# UNITED STATES PATENT AND TRADEMARK OFFICE

10/797,255

# Office Action Summary

Application No.	Applicant(s)	
10/797,255	ROARTY, BRIAN P.	
Examiner	Art Unit	
Erin M. Boyd	3663

Gray French; Figure 1, page 67

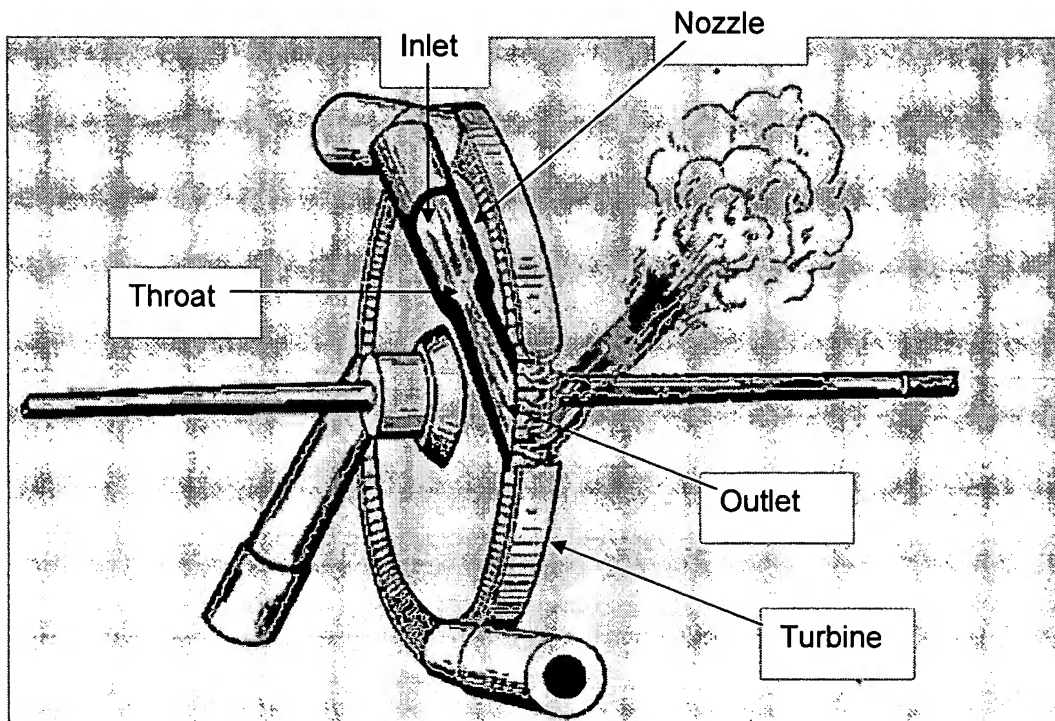
24. Regarding Claim 4, Gray French teaches a system comprising a nozzle having an inlet, a throat, and an exhaust (see figure below); a fluid flowing through the nozzle; and a means (i.e. turbine) for transforming the flow from the exhaust into work outside the system. Gray French fails to teach a means embedded within the nozzle for transferring energy into and heating the nozzle, thereby indirectly transferring energy into and heating the fluid and inducing a phase change in the fluid. Patterson teaches a means 38/44/36 embedded within a nozzle 12 for transferring energy into and heating the nozzle 12 (column 2, lines 15-17); thereby indirectly (through means 36) transferring energy into and heating the fluid and inducing a phase change in the fluid (column 3, lines 59-60).

A motivation for indirectly supplying energy to the fluid in the manner above described is to form the necessary electrolytic current flow path between the cathode 38

and anode 44 (U.S. Patent No. 5,318,675; Patterson, column 5, lines 56-59). Thus, it would have been obvious to one of ordinary skill in the art at the time of the invention to embed said means 36 in the nozzle 12.

25. Regarding Claim 5, Gray French teaches a system wherein the cross-sectional interior volume of the inlet, throat, and exhaust of the nozzle vary only across one plane perpendicular to the axis of the fluid flowing through the nozzle (see figure below).
